**SAFETY RECALL NOTICE**

**VOLUNTARY SAFETY RECALL CAMPAIGN # 09V-111**

## 1125R, XB12R AND XB12Scg BRAKE LINE RECALL

SUBJECT: <b>BRAKE BOOSTER CHECK VALVE REPLACEMENT SAFETY RECALL CAMPAIGN</b>			No: <b>SR-09-002</b>
			DATE: <b>April, 2009</b>
			MODEL: <b>2008-09 Lancer, 2008-09 Outlander</b>
CIRCULATE TO:	<input checked="" type="checkbox"/> GENERAL MANAGER	<input checked="" type="checkbox"/> PARTS MANAGER	<input checked="" type="checkbox"/> TECHNICIAN
<input checked="" type="checkbox"/> SERVICE ADVISOR	<input checked="" type="checkbox"/> SERVICE MANAGER	<input checked="" type="checkbox"/> WARRANTY PROCESSOR	<input checked="" type="checkbox"/> SALES MANAGER

Figure 1. Reflector/Rhino Tape Location (XB12Scg)

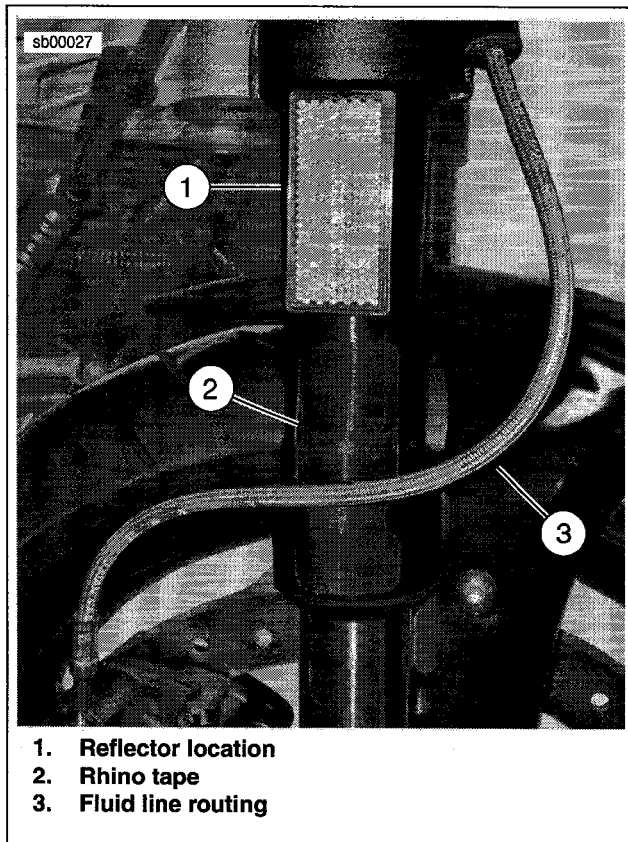
1. **XB12R/XB12Scg:** See Figure 1. Remove the reflectors on the outer fork tubes and install **new** reflectors pressed up against the lower triple clamp.

- Remove the reflectors on the outer fork tubes and install **new** reflectors pressed up against the lower triple clamp.
- Fit the rhino tape against the lower edge of the outer fork tube and press into place.

Figure 2. Front Brake Line Guide

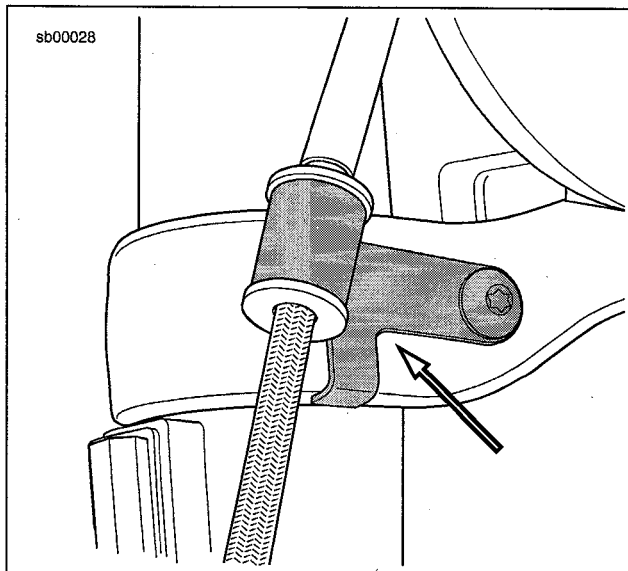
- Drain the brake fluid. See the service manual.
- Remove the banjo bolt at the front brake caliper.
- Remove the P-clamp from the lower triple clamp and the line.
- Re-route the brake line outside of the front fork.
- Install the banjo bolt with **new** crush washers. Tighten to 16-20 **ft-lbs** (22-27 Nm).
- Press the rubber grommet around the front brake line into the front brake line guide.
- Install the guide and tighten to 36-60 **in-lbs** (4-7 Nm).

**AIR INTAKE HOSE REMOVAL**

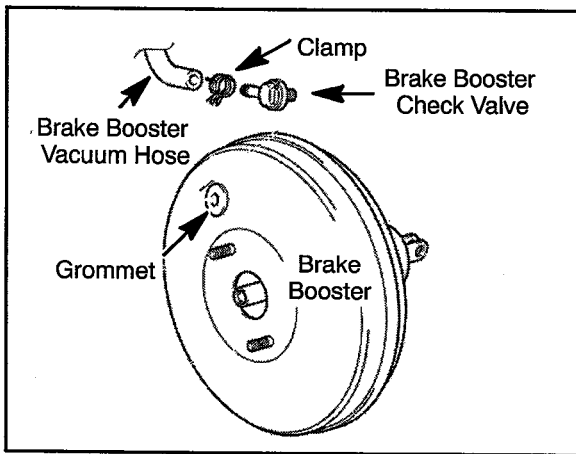
2. Using pliers, compress the clamp securing the breather hose retaining clip and slide the clamp away from the fitting on the air intake hose.
  3. Remove the breather hose from the air intake hose.
- NOTE:** If the fitting comes out of the air intake hose, re-install it and continue with the next step.
4. Loosen 2 band clamps and remove the air intake hose.

**Reinstallation of the air intake hose is the reverse of removal. Refer to the illustration accompanying step 2 and torque the band clamps to the specification shown.**

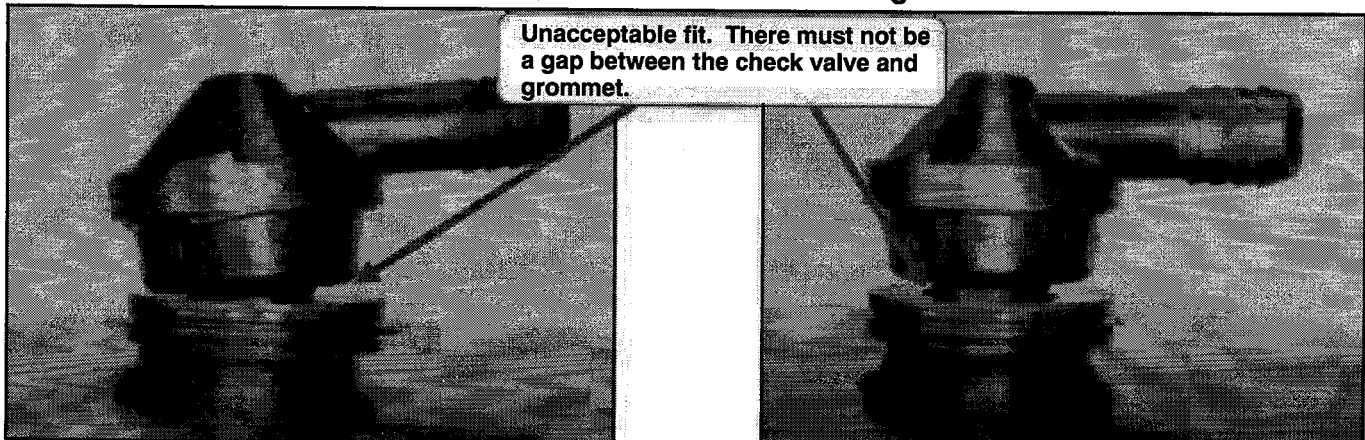
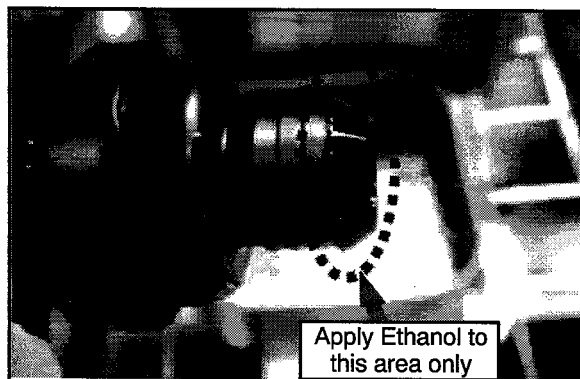
11. Install a new brake booster check valve **facing the same direction as the one you removed**. Insure that the check valve is completely inserted and that no gap exists between the valve and the grommet (see following photos).

Insure the check valve fits flush to the grommet. There must not be a gap between the base of the check valve and the grommet.

**NOTE:** If necessary, you may use ETHANOL ONLY (ethyl alcohol) as a lubricant by coating only the bevelled surface of the check valve before inserting it into the grommet.
